# APPENDIX 49A

## UNITIZATION PROCEDURES FOR BOXED AMMUNITION AND COMPONENTS ON 4-WAY ENTRY PALLETS

BURSTER, PROJECTILE, PACKED 100 PER WOODEN  
BOX, UNITIZED 35 BOXES PER 35" X 45 $\frac{1}{2}$ " PALLET;  
APPROX BOX SIZE 16 $\frac{3}{4}$ " L X 9 $\frac{5}{8}$ " W X 11 $\frac{25}{32}$ " H

REVISION NO. 1, DATED OCTOBER 1982, CONSISTS OF:

### REVISION

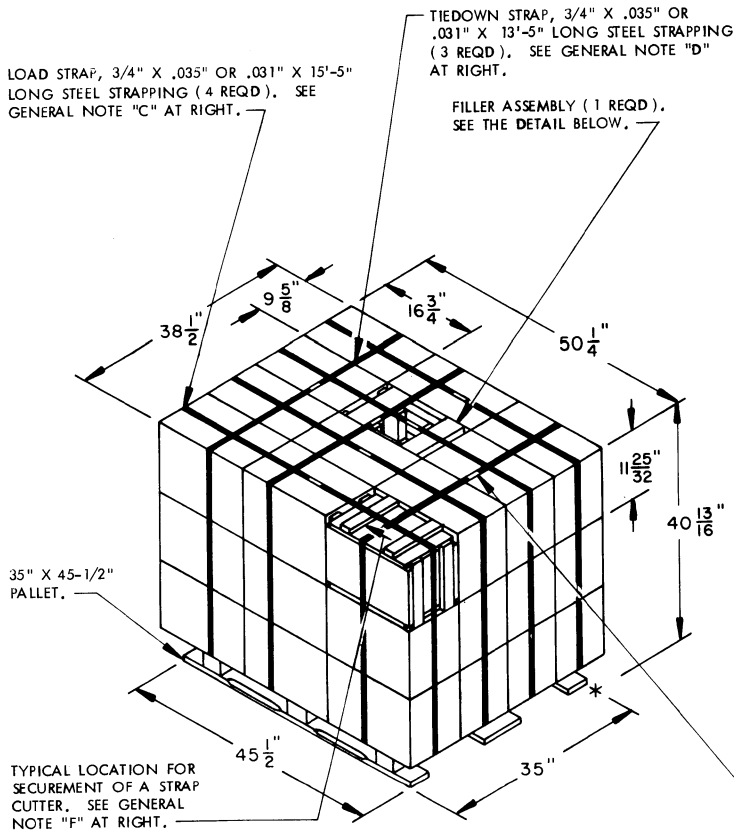
1. CHANGING BOX DIMENSIONS.
2. CHANGING UNITIZATION PROCEDURES TO CONFORM TO 1. ABOVE.
